## CHRYSLER A604 (41TE) UPDATE HANDBOOK

### "UPDATE HANDBOOK"

Since the introduction of the Chrysler A604 (41TE) transaxle in model year 1989, there have been many engineering changes to greatly improve pleaseability, durability and driveability concerns. These changes have affected nearly every part used in the A604 (41TE) transaxle. This "Update Handbook" will explain each change, the reason for the change, any interchangeability concerns created by the change and any part numbers necessary to "Update" your unit. This booklet has been designed to be used in conjunction with the assembly and disassembly manual, also available from ATSG.

Figure 16

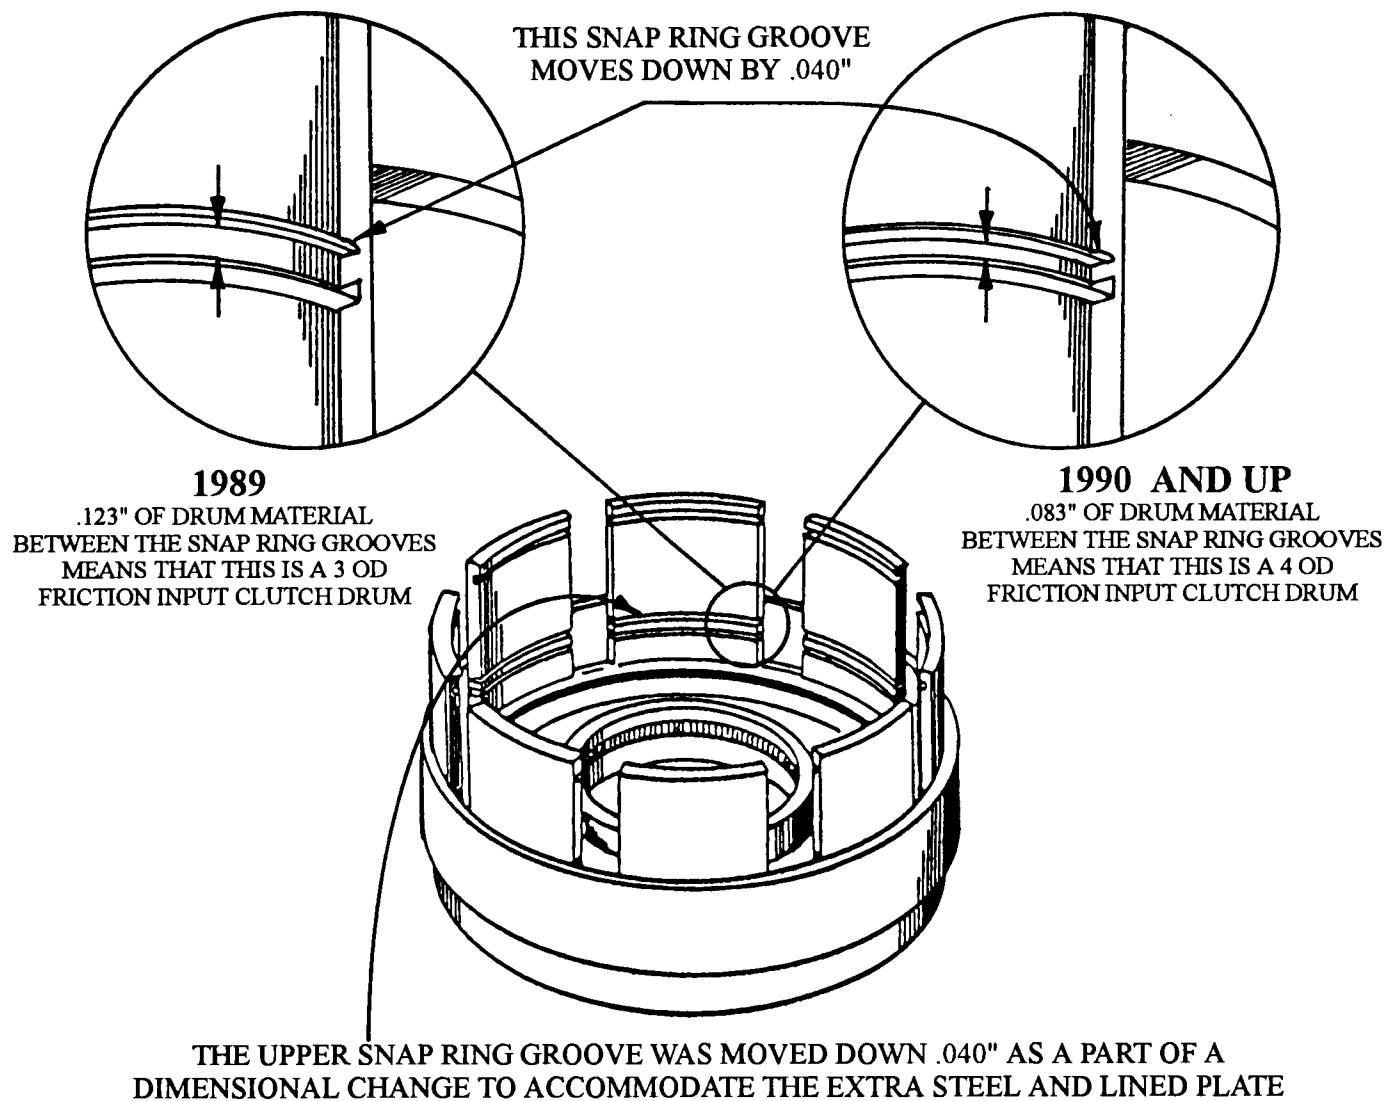
- (3) **INPUT CLUTCH RETAINER** - The underdrive/overdrive reaction plate tapered snap ring groove was moved "Down" by .040" (Can be detected visually) to make room for the added lined and steel plates (See Figure 16). This also necessitated a change to be made to the underdrive/overdrive reaction plate as explained below. Another change that occurred at the same time is the underdrive clutch outer lip seal groove depth is .040" "Shallower" to accommodate a new underdrive clutch outer lip seal (See Figure 17).

Figure 20

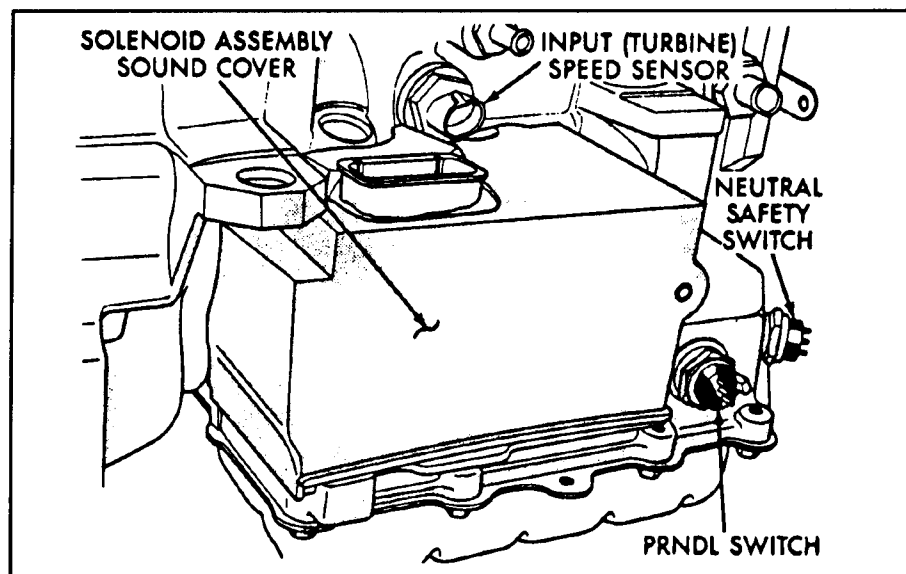
**CHANGE:** PRNODL Switch and Neutral Safety Switch have been changed for the 1990 model year, as well as the vehicle wiring harness connectors. Refer to Figure 20 for location of switches on the transaxle.

Figure 28

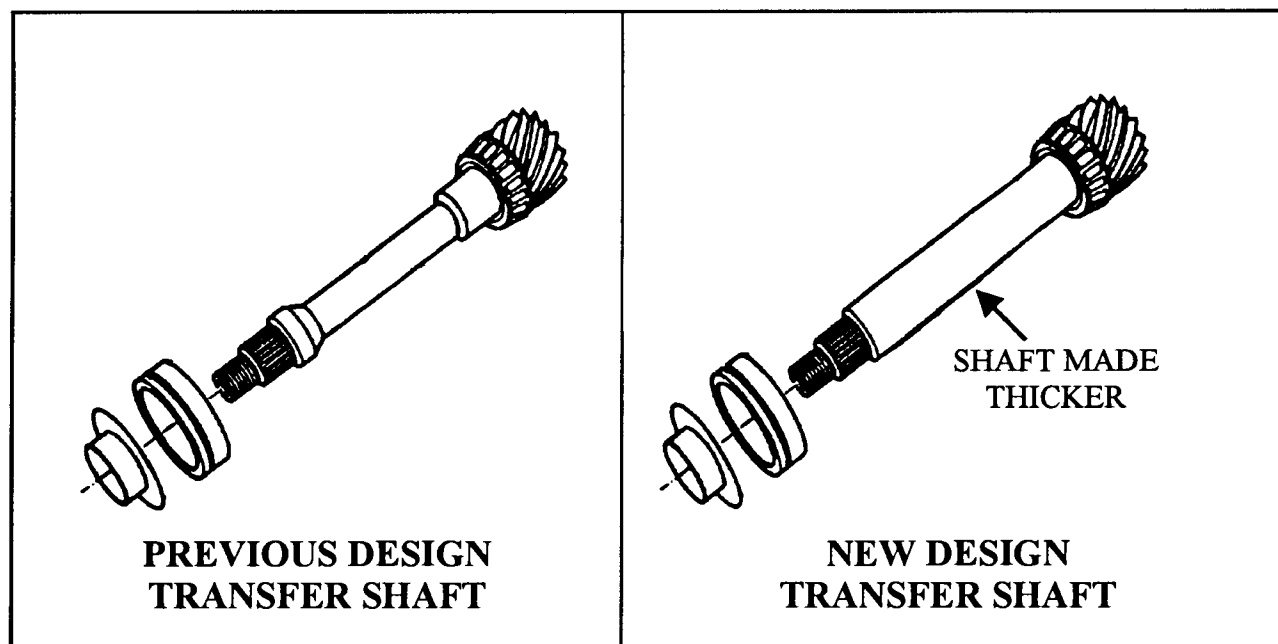
**CHANGE:** A thicker transfer shaft was made as a running change in 1990 and continues through to current production (See Figure 28).

- (1) **TRANSFER SHAFT** - The transfer shaft between the transfer gear end and the threaded end of the shaft increased in diameter to accommodate torque transfer (See Figure 28).

Figure 32

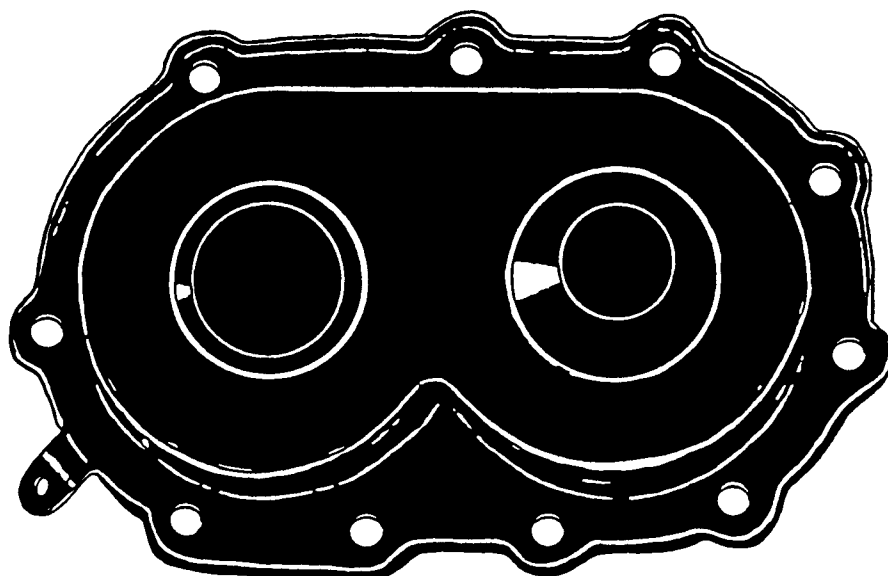
- (4) **TRANSFER SHAFT NUT** - Added Locktite patch to the thread area and cadmium plated for a more stable torque retention.
- (5) **TRANSFER GEAR COVER** - Has an added dimple in the cover to accommodate the increased head thickness of the output shaft bolt as shown in Figure 32.

Figure 37

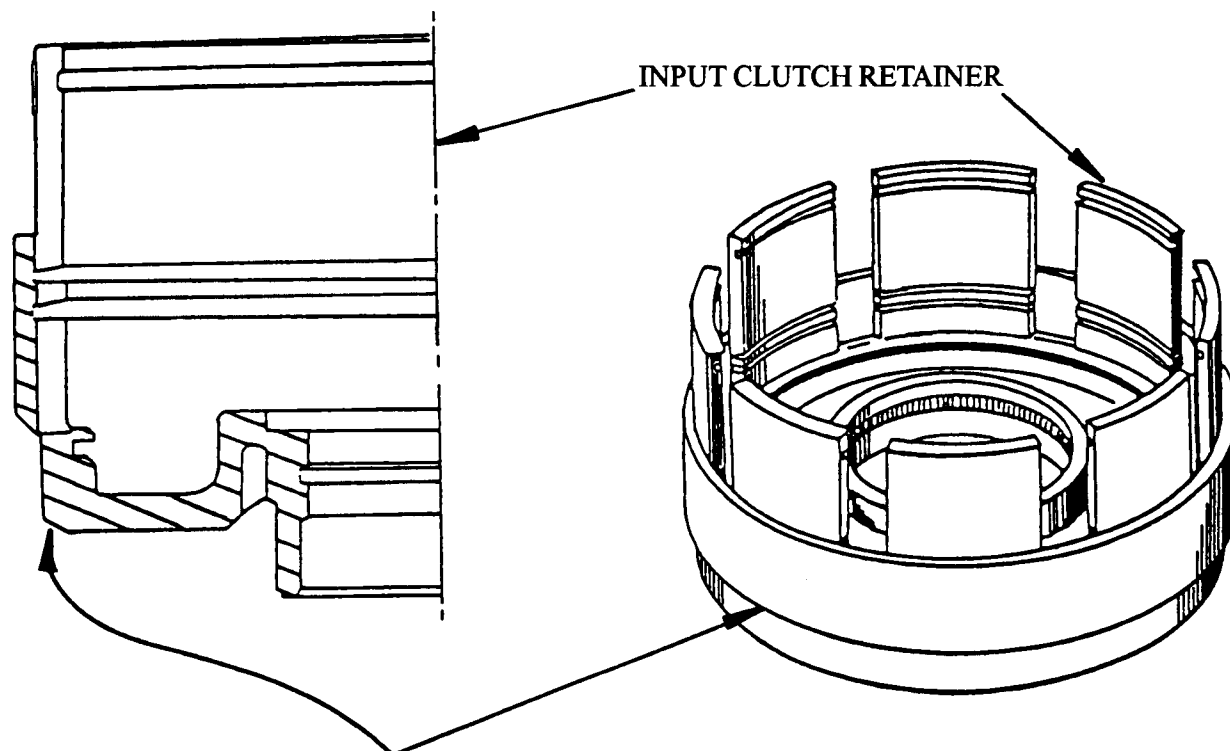
1990 1/4 INPUT CLUTCH RETAINER HAS A REVISED  
RADIUS LOCATED HERE, ON THE OUTSIDE DIAMETER  
TO REDUCE THE CHANCE OF DAMAGE TO LIP SEAL

Figure 39

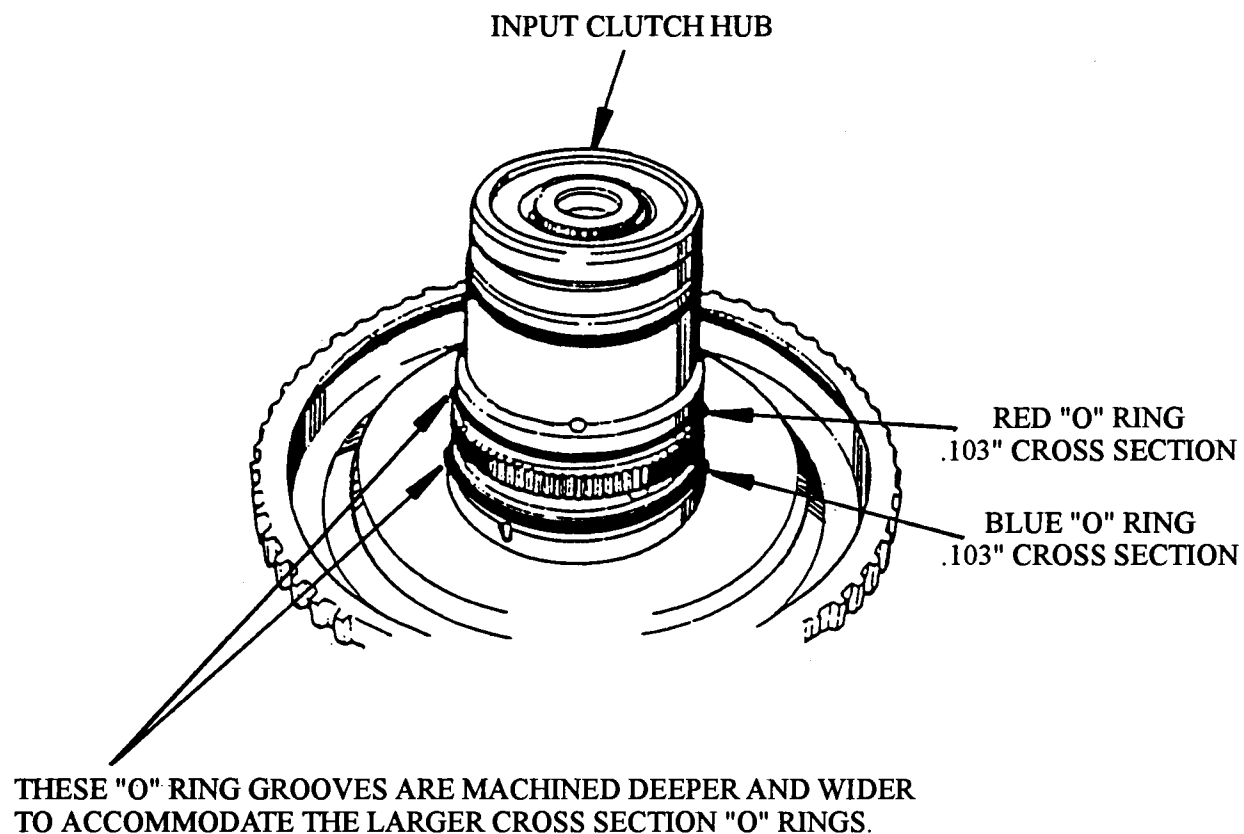
- (1) **INPUT CLUTCH HUB** - The "O" ring grooves on the Input Clutch Hub are cut deeper and wider to accommodate the larger cross section color coded "O" rings (See Figure 39).

Figure 43

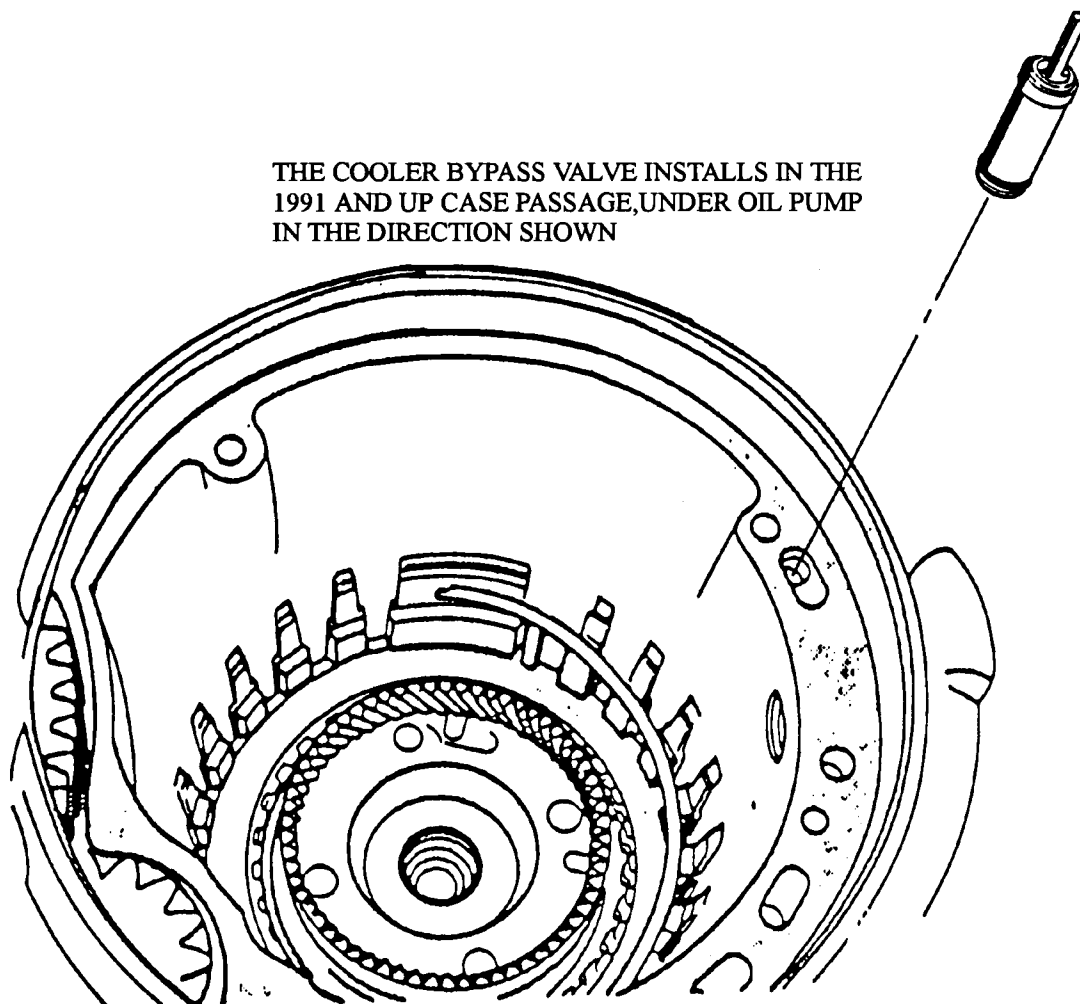
**CHANGE:** Beginning in 1991 model A604 transaxles, there has been a "Cooler Bypass Check Valve Assembly" added in the transaxle case behind the oil pump. (See Figures 42 and 43).

- (1) **COOLER BYPASS CHECK VALVE** - added into the case cooler passage behind the oil pump (See Figure 43). If cooler oil flow is restricted, or blocked, the new check valve will open, and allow cooler feed oil direct into the lube circuit to prevent transaxle damage. Normal operation is resumed after oil temperature is warm enough to again flow through the cooler. (See Figure 42).  
**NOTE:** Customers should be advised to let the vehicle warm-up thoroughly before attempting to drive the vehicle, especially in the colder climates.
- (2) **TRANSAXLE CASE** - The new case has added material between the two cooler line fittings, to accommodate the machining process needed for the new cooler bypass check valve assembly (See Figure 43).
- (3) **VALVE BODY SPACER PLATE** - Lube feed hole in spacer plate has been enlarged to .112", as shown in Figure 44.

THE COOLER BYPASS VALVE INSTALLS IN THE 1991 AND UP CASE PASSAGE, UNDER OIL PUMP IN THE DIRECTION SHOWN

Figure 62

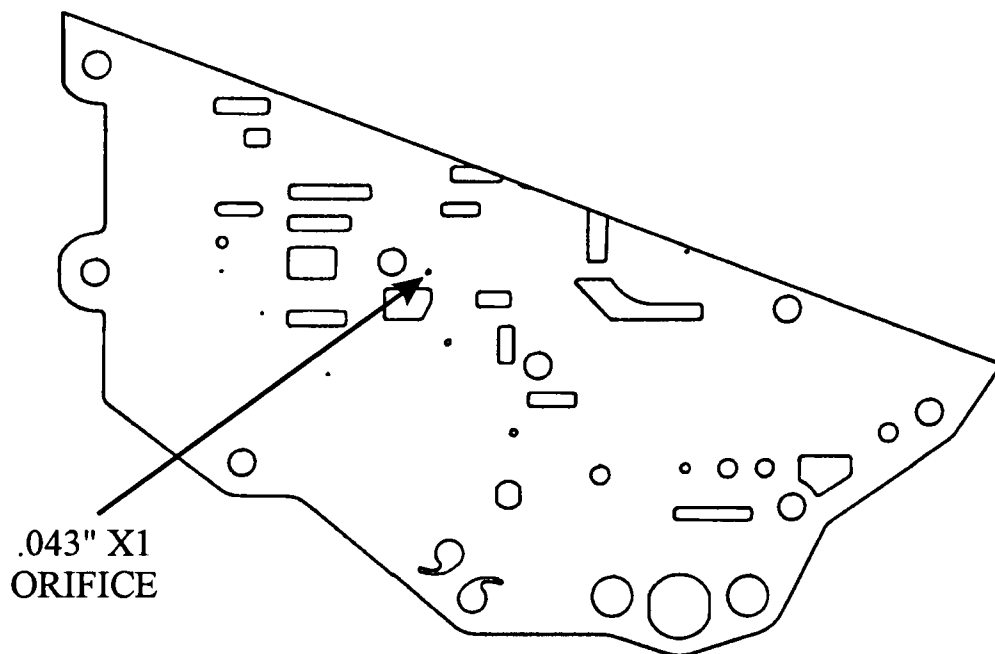
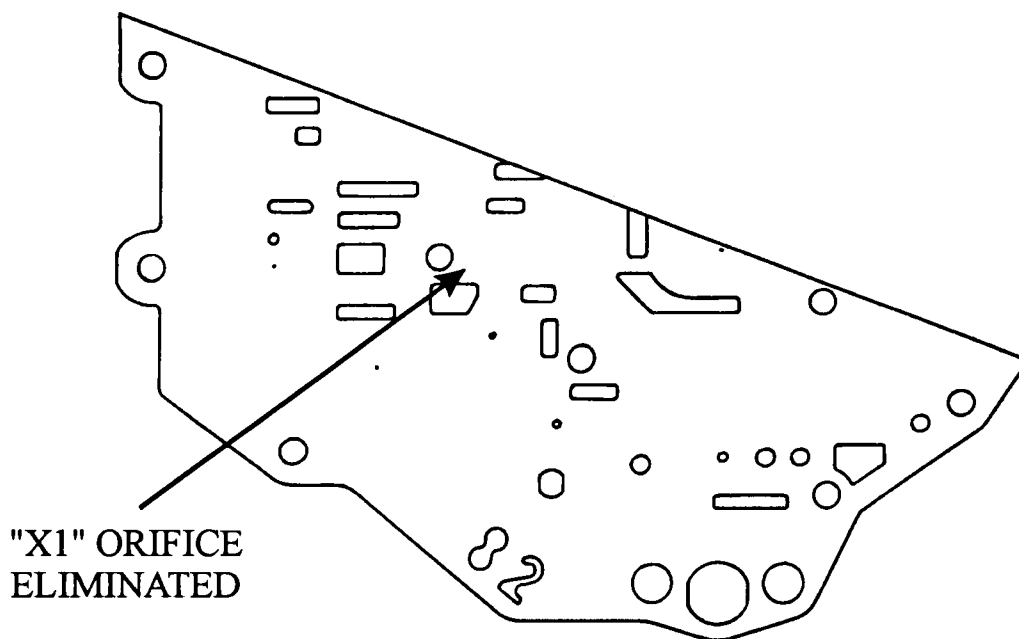
- (1) : **SPACER PLATE:** The "X1 Orifice" in the spacer plate has been eliminated as shown in figure 62. The plate can be easily identified by the number "82" that is punched through the plate (See Figure 62).
- (2) : **PRESSURE REGULATOR VALVE:** A ground step has been machined to the inner land on the Pressure Regulator Valve causing two different diameters to exist on one land (See Figure 63). There are no obvious or visible signs or identification marks to indicate the updated Pressure Regulator Valve. Careful measurement of the valve land is needed to properly identify the valve (See Figure 63). The spring side of the land measures approximately .6255". The opposite end of the same land will measure approximately .6245" (See Figure 63).

The new "82" spacer plate replaces the previous "96" spacer plate and can retrofit back to all valve bodies and Transfer Plates that use the # 96 spacer plate **provided that the new pressure regulator valve is used together with the # 82 spacer plate.** Valve bodies that use a 96 spacer plate has a casting number of 4511644 (See Figure 52 on Page 68). Transfer Plates that use the # 96 spacer plate has a casting number of 4511645 (See Figure 54 on Page 70).

Figure 64

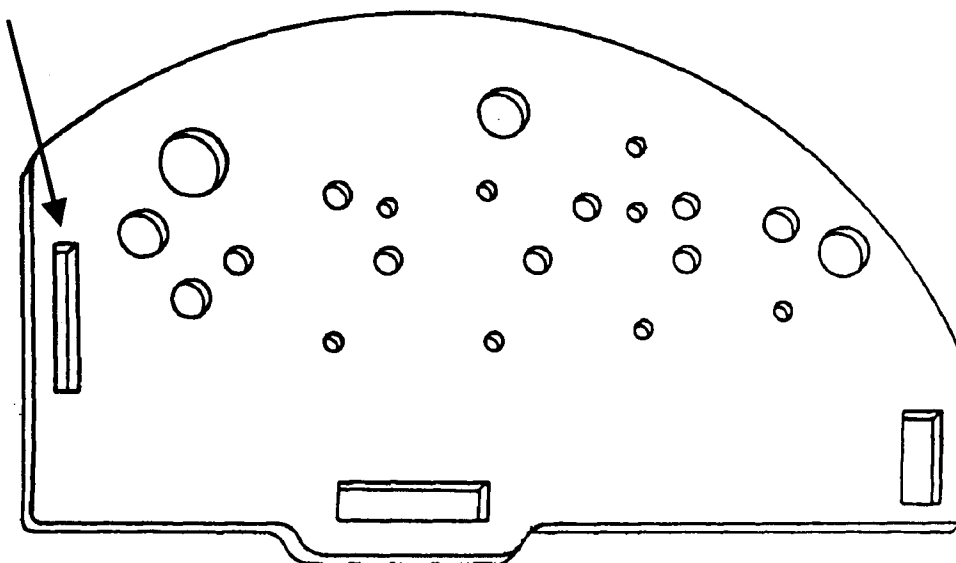
**CHANGE :** A running change for 1994 and all 1995 and up model years was made to the solenoid sound cover and spacer plate (See Figure 64).

- (1): **SOLENOID SOUND COVER** - An additional locking tab was added to the sound cover for a more secure fit to the solenoid spacer plate.
- (2): **SOLENOID SPACER PLATE** - The solenoid spacer plate received an added slot to accommodate the additional locking tab made to the solenoid sound cover. There were also subtle changes made to the venting holes and slots found in the spacer plate (See Figure 64).

Figure 65

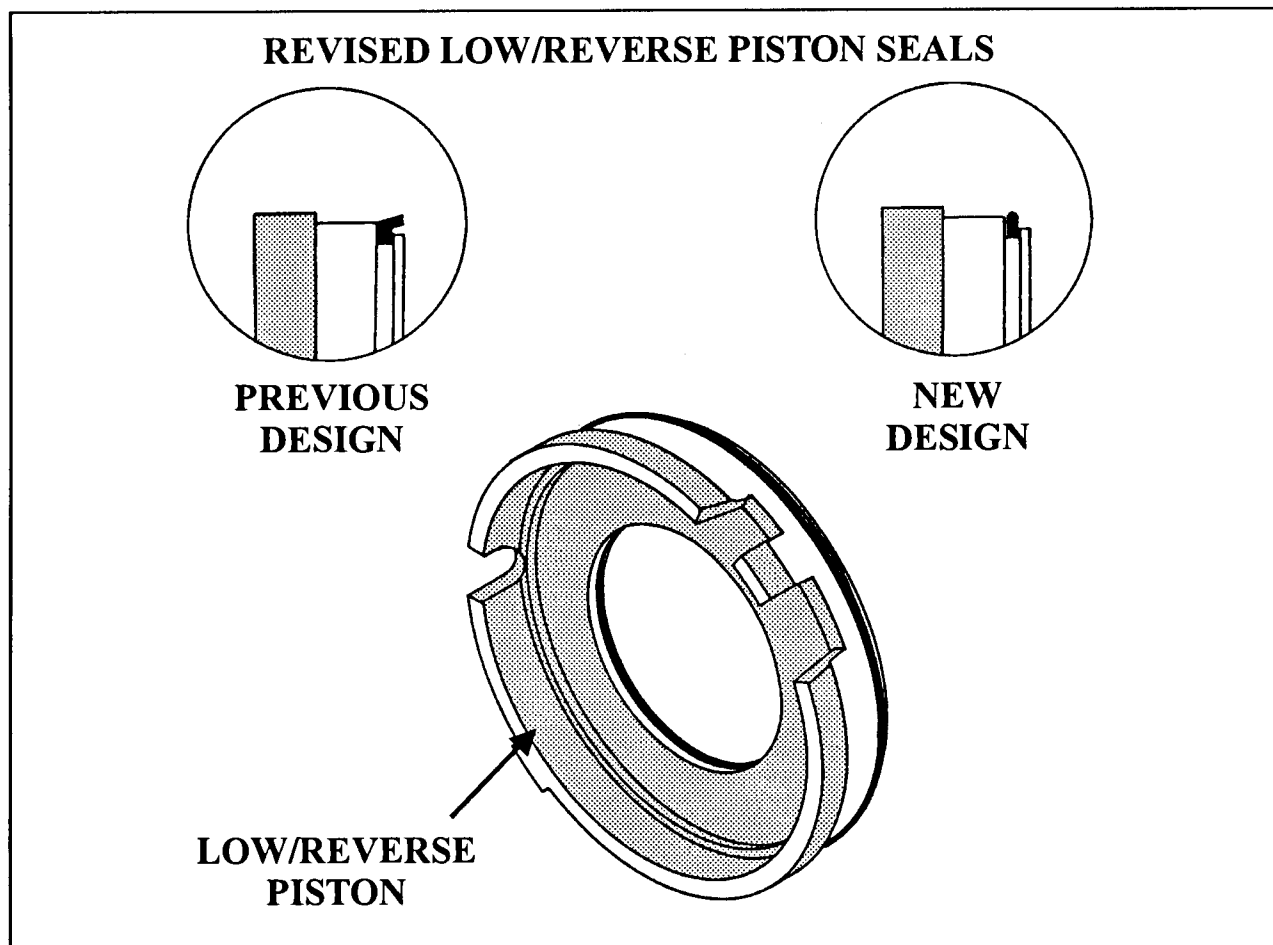
**CHANGE:** Beginning at the start of production for 1995 model year, all Chrysler A604 (41TE) and A606 (42LE) transaxles were produced using revised seals for the Low/Reverse piston. The previous "Lip" type seals have been replaced by a "D" Ring type seal for both inner and outer seals, as shown in Figure 65.

- (1) **LOW/REVERSE PISTON SEALS** - Both the inner and outer lip seals have been replaced by a "D" Ring type seal, as shown in Figure 65. There were no dimensional changes necessary to the Low/Reverse piston to accommodate the new "D" Ring seals. The seals are available under OEM part number 4659185 for the outer seal, and 4659184 for the inner seal.
